# STAFF REPORT

SUBJECT: H-2021-0056  
Pera Place Subdivision

LOCATION: The site is located at 4600 W. Daphne Street, 4546 W. Daphne Street, and Parcel S0427325702, near the northeast corner of N. Black Cat Road and W. McMillan Road, in the NW ¼ & the SW ¼ of the SW ¼ of Section 27, Township 4N., Range 1W.

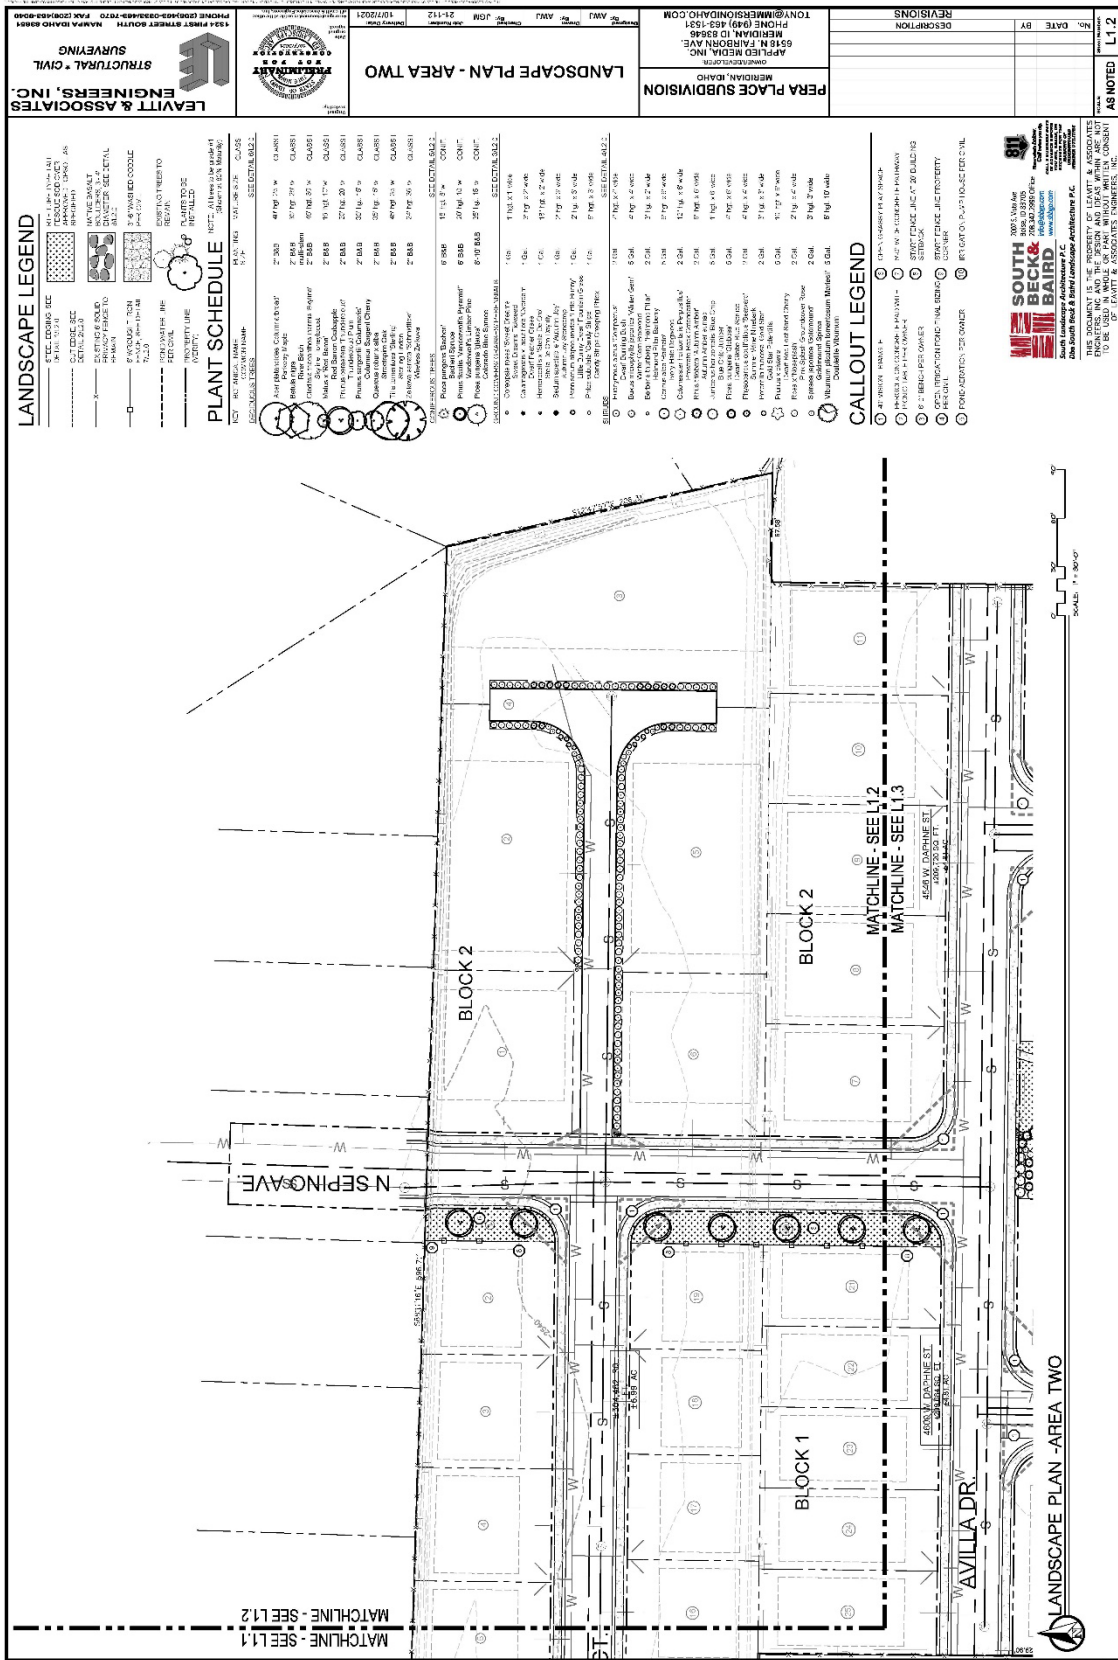
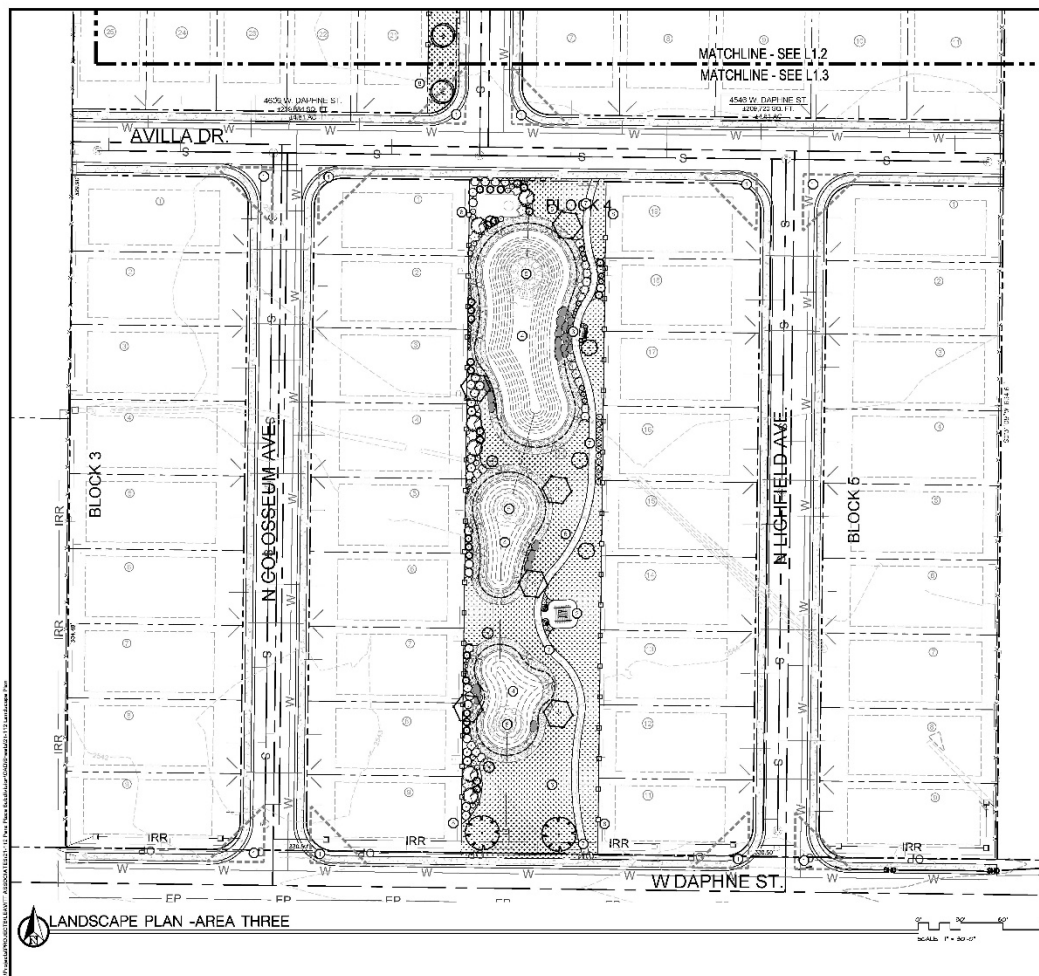
3. The revised preliminary plat included in Section VII.B, dated September 17, 2021, shall be revised as follows prior to submitting for Final Plat approval:

- a. Add a plat note stating that direct lot access to N. Black Cat Road is prohibited.
    - b. Remove the non-buildable lot (Lot 10, Block 1) for the Poorman outparcel septic drain field and show it as part of the larger common lot (Lot 8, Block 1).

LANDSCAPE LEGEND

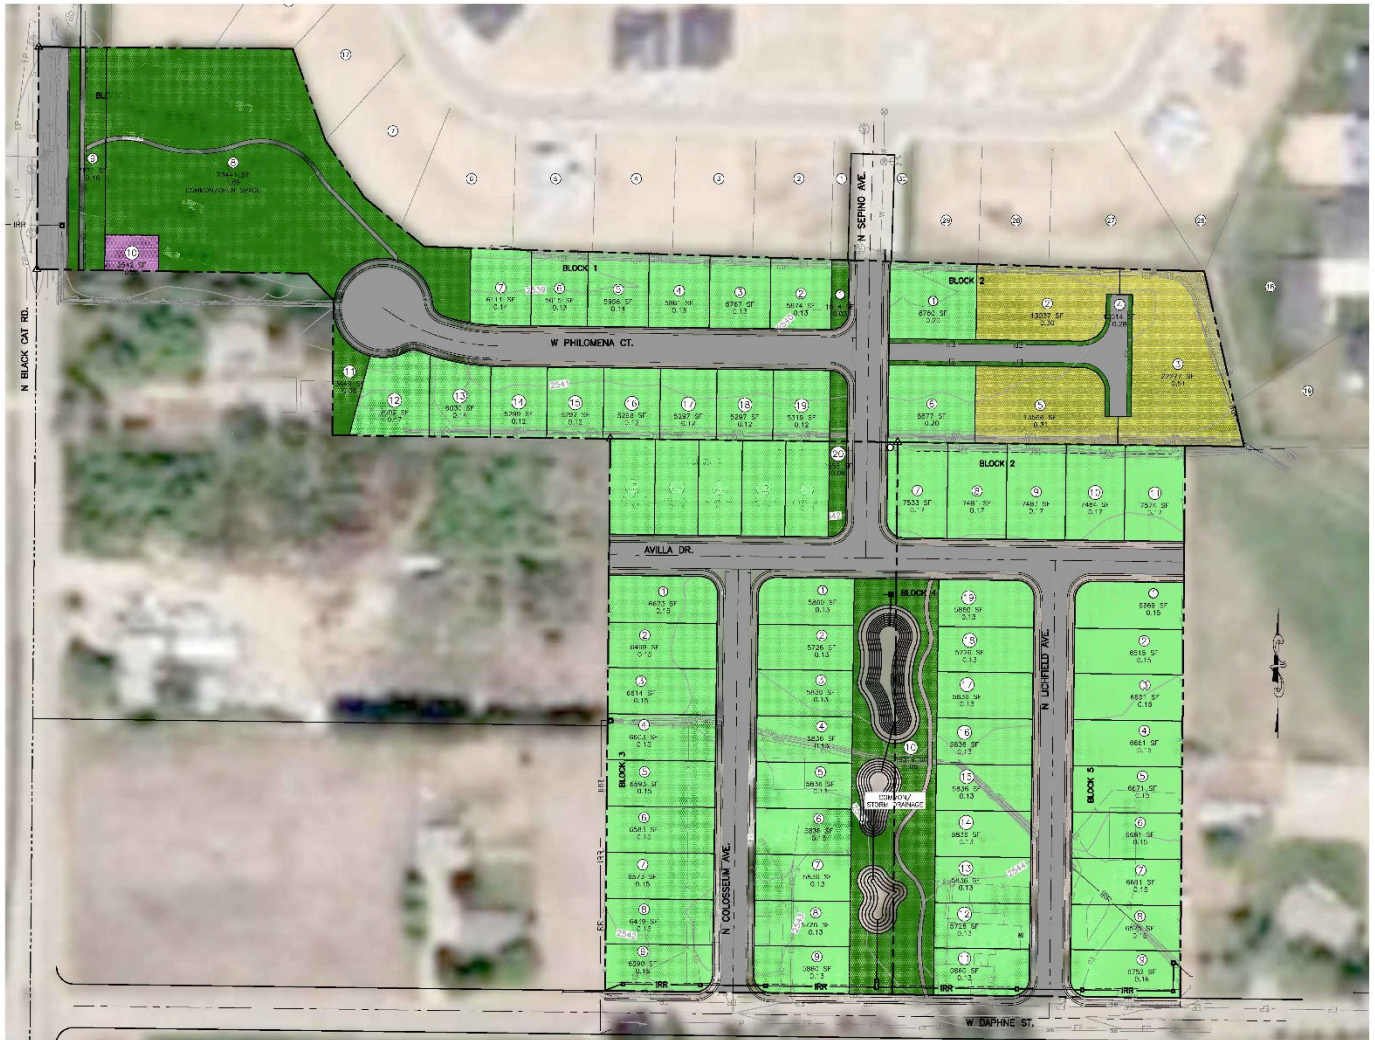
*The landscape buffer along N. Black Cat Road is required to be 25' wide and vegetated in accord with UDC 11-3B-7. The submitted landscape plans show compliance with UDC requirements for the number of trees, tree spacing/grouping, and additional vegetative ground cover with two (2) new trees and the existing conditions of multiple existing and mature trees in the buffer area. The landscape plans and plat also show this buffer to be within a 30-foot common lot exceeding the 25-foot requirement.*

***As noted above, the Applicant is proposing a micro-pathway from the cul-de-sac to the detached sidewalk along Black Cat through the existing tree area. Because this area is densely vegetated and has a relatively large gap between any roads (approximately 400 feet of micro-path), Staff is concerned with safety while traversing this path. Staff is unaware if these trees are pruned to accommodate better visibility or the level of visibility between the proposed cul-de-sac and Black Cat. Therefore, Staff is including a DA provision to install and maintain lights along this micro-path to help with pedestrian safety and meet CPTED policies in this area.***

*The Applicant is required to dedicate additional right-of-way for Black Cat total 50 feet from centerline. This additional dedication is for future widening of Black Cat but in the meantime, UDC 11-3B-7C.5 requires a gravel shoulder of no more than 10 feet with the remaining area to be vegetated with lawn or other vegetative ground cover; gravel is not a sufficient ground cover material. According to the submitted landscape plans, the Applicant is not showing compliance with this code section. So, Staff is recommending a condition of approval to revise the landscape plans to meet this requirement prior to Final Plat submittal.*

4. The landscape plan included in Section VII.C, dated October 7, 2021, shall be revised as follows prior to submitting for Final Plat approval:
    - a. Any landscaping within the ACHD right-of-way shall be landscaped in accord with UDC 11-3B-7C.5.
